Access Compliance Report

Public Rights-of-Way

Intersection ID: 12278	Main Street: SEIGLE_AV	Cross Street: VAN_EVERY_ST	Location: S
ADA ID: 36A959C1CE18	Ramp Type: PerpDiag	Initial Pass/Fail: Fail	Overall Compliance: No
		Severity Score: 25

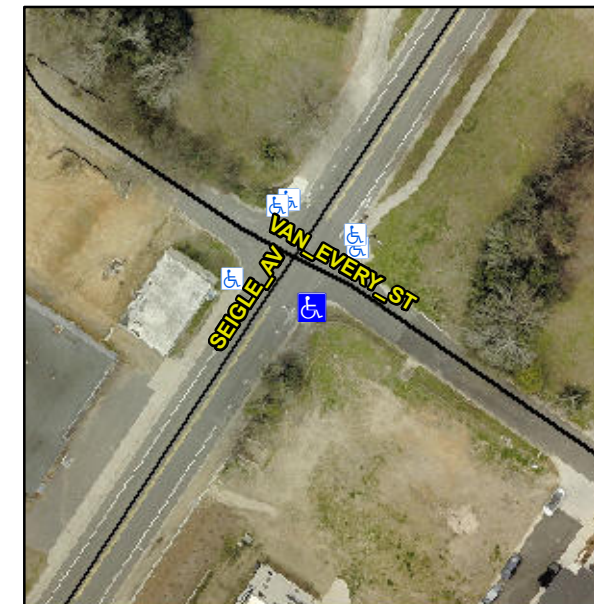
Not Found, R304.5.3

Compliance	Description	Data	Compliance	Description	Data
N/A	Ramp Length (in)	40.0	Yes	Ramp Slope (%)	5.3
Yes	Ramp Width (in)	48.0	No	Ramp XSlope (%)	7.2
N/A	Flare Type LT	N/A	N/A	Flare Type RT	N/A
N/A	Flare Slope LT (%)	N/A	N/A	Flare Slope RT (%)	N/A
N/A	Flare Traversable LT?	N/A	N/A	Flare Traversable RT?	N/A
N/A	Landing Length (in)	N/A	N/A	DWS Provided?	N/A
N/A	Landing Width (in)	N/A	N/A	DWS Contrast?	N/A
N/A	Landing Slope (%)	N/A	N/A	DWS Length (in)	N/A
N/A	Landing X Slope (%)	N/A	N/A	DWS Full Width?	N/A
N/A	Landing Curb? (Y/N)	N/A	N/A	DWS Offset (in)	N/A
N/A	Shared Landing?	N/A			
N/A	Gutter Ponding?	N/A	N/A	Gutter Slope (%)	N/A
N/A	Gutter Lip Ht (in)	N/A	N/A	Gutter X Slope (%)	N/A
N/A	Painted X Walk1?	No	N/A	Painted X Walk2?	No
	X Walk 1 Direction	To NE		X Walk 2 Direction	To NW
N/A	X Walk 1 Width (in)	N/A	N/A	X Walk 2 Width (in)	N/A
	X Walk 1 Slope (%)	9.1		X Walk 2 Slope (%)	3.1
	X Walk 1 X Slope (%)	1.7		X Walk 2 X Slope (%)	6.9

Remove & Replace Curb Ramp With Two New Directional Ramps or Equivalent.
